From: Detterman, Karel, Env. Health
Sent: Friday, October 26, 2018 5:03 PM
To: Darren Croteau
Cc: Ben Garfinkle; Jay; Nicole Gleason; Roe, Dilan, Env. Health
Subject: RE: 2407 San Jose Avenue, Alameda - Site Cleanup Program Case RO0003253 and GeoTracker Global ID T10000010519
Attachments: Attachment_1_and_GeoTrackerInstructions_2017-12-14 K.pdf

CLIENT:	Garfinkle Trust
PROJECT:	2407 San Jose Avenue Alameda, CA
PROJECT NUMBER:	0196.001.002

Proposed Grab Groundwater Sample Location

FIGURE 2

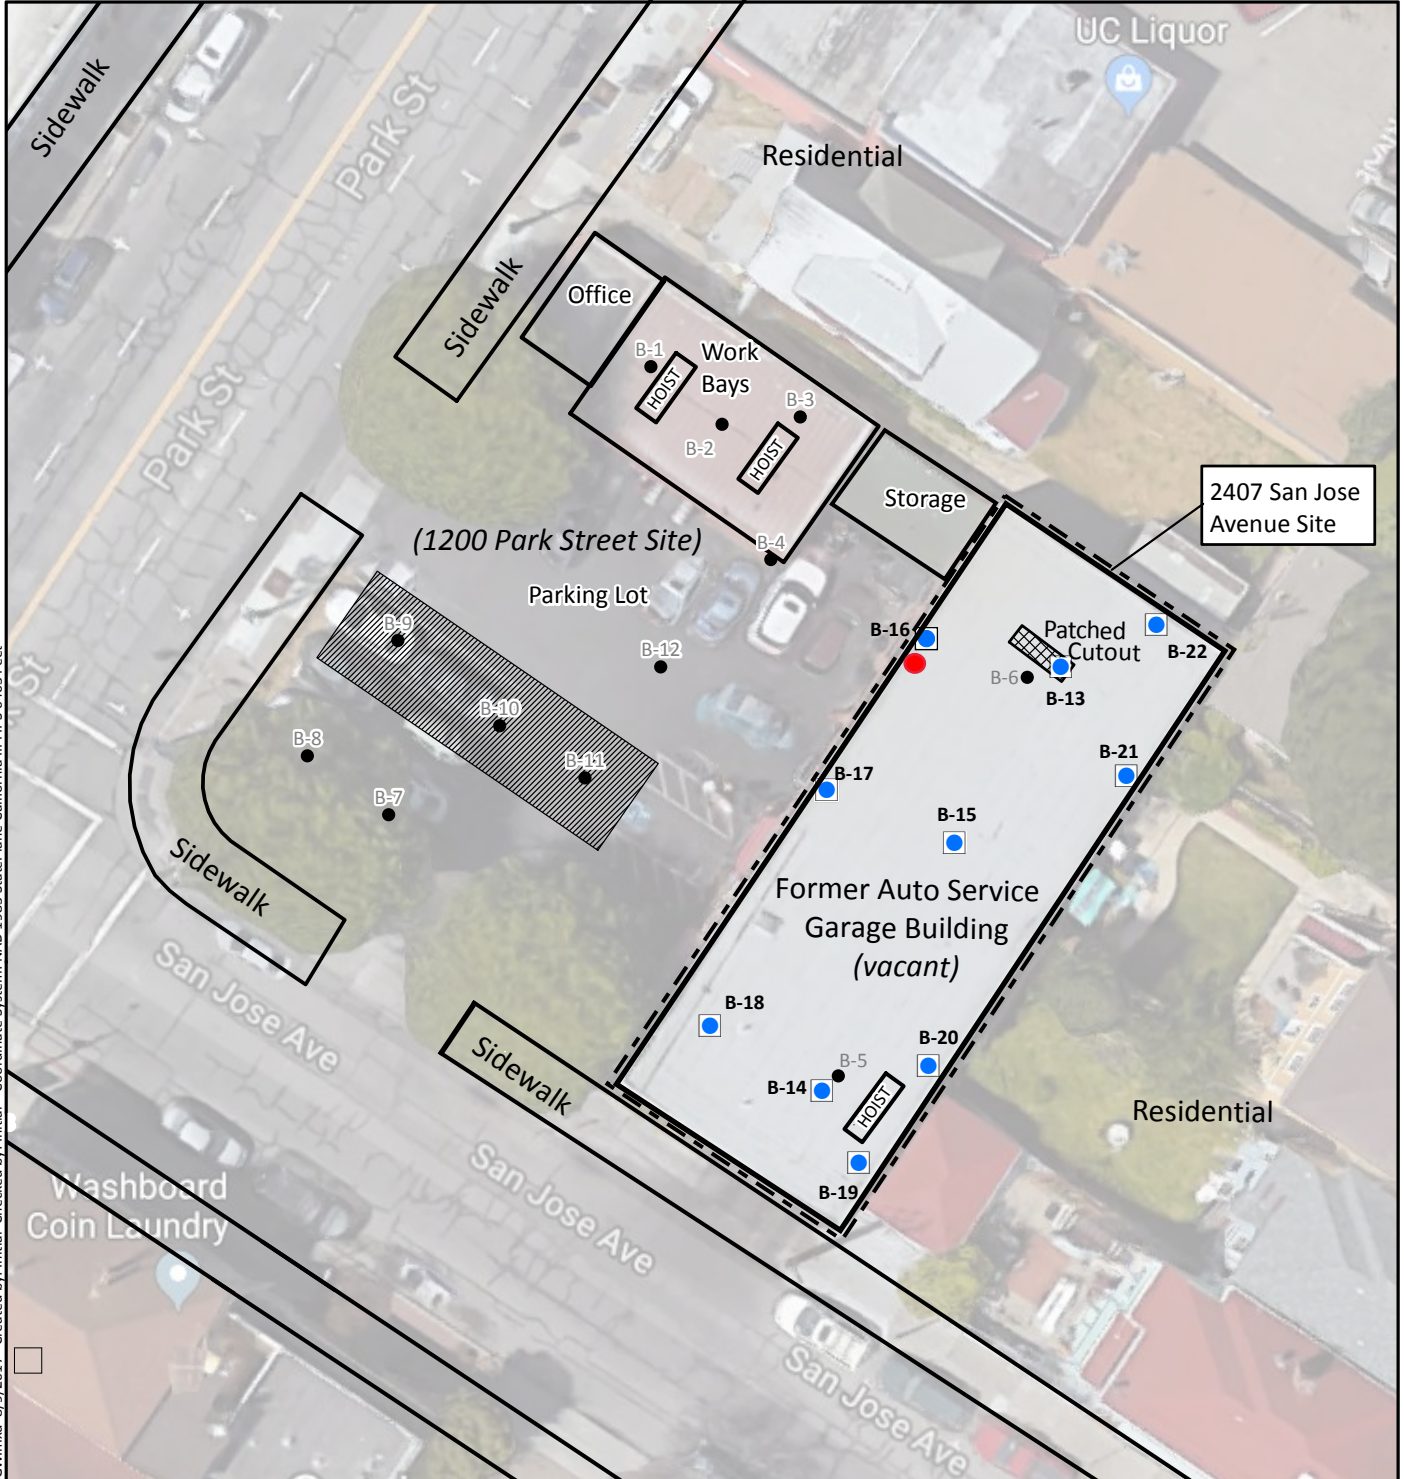
Thank you for submitting the e-mailed work plan and figure describing the collection of a grab groundwater sample next to B-16 at the above referenced case. The purpose of the grab groundwater sample collection is to determine if the source location of the Total Petroleum Hydrocarbons as Diesel (TPHd) detected at 84,000 microgram per liter (ug/L) in B-6 is the patched cutout or from the adjoining fuel leak case. Please note, Alameda County Department of Environmental Health's (ACDEH) will first review the submitted Soil and Groundwater Investigation Report prior to committing to a Site Cleanup Program (SCP) case closure decision including initiation of the 30-day public comment period.

The e-mailed work plan is approved for implementation provided that all of the modifications specifically requested in the following technical comments are addressed and incorporated during the field implementation. Submittal of a revised work plan or a work plan addendum is not required unless any alternate scope of work outside that described in the work plan or the technical comments are proposed. We request that you address the following technical comments, perform the proposed work, and send us the report described below. Please provide 72-hour advance written notification to this office (e-mail preferred to: karel.detterman@acgov.org) prior to the start of field activities.

1. Please include with the soil and groundwater investigation letter report the boring log (including PID readings), laboratory analytical data, chain of custody, figures, a summary table of all soil and groundwater data for the SCP case, the boring permit, waste disposal documentation.
